# Field Inspection Report

## -Pebble Copper/Gold Exploration Project-

Inspection Date: May 7, 2008

APMA No.: A086118

Figure 1. Approximate Location of drilling rigs.

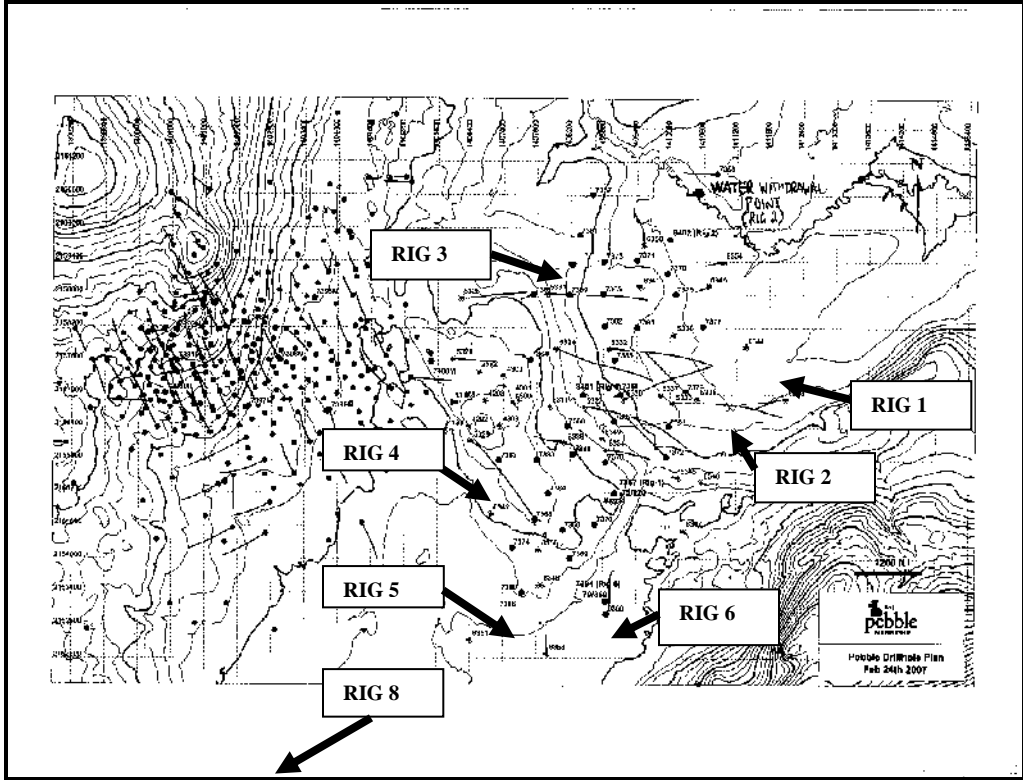
- Complete:  
Partial: **Visited four of the eight drill rigs that were in operation or being installed (Figure 1).**
- Follow-up:
- Response to complaint:
